# Rezoning Transportation Analysis

Petition Number: 2017-074

General Location Identifier: 08314303

## Revision Log:

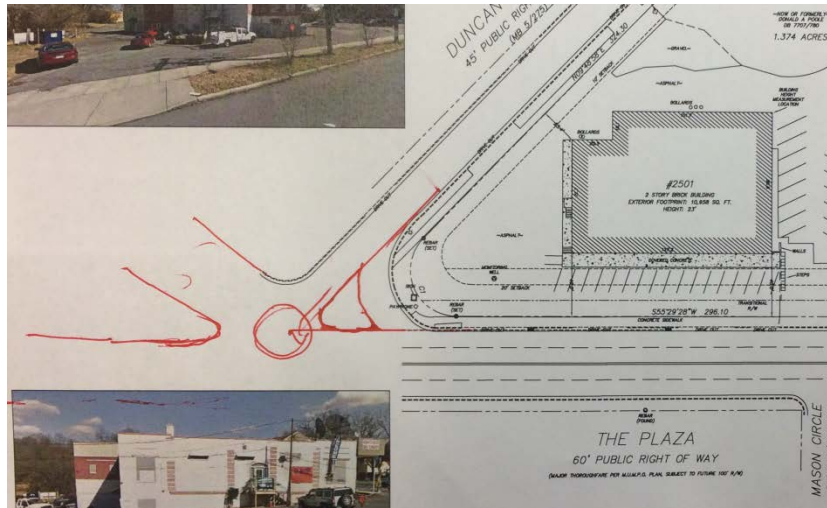
1. **Technical Correction** Label future curblines dimension (8' from exiting curblines) on The Plaza. ~~Curblines~~ ~~The proposed zoning district has a setback measured from back of the existing or~~

~~proposed future curblane. The location of the future back of curb on Duncan Avenue and Drummond Avenue will remain the same unless the petitioner requests on-street parking which must be recessed due to existing roadway widths. The future back of curb on The Plaza is 8 feet behind existing to account for a future buffered bike lane.~~
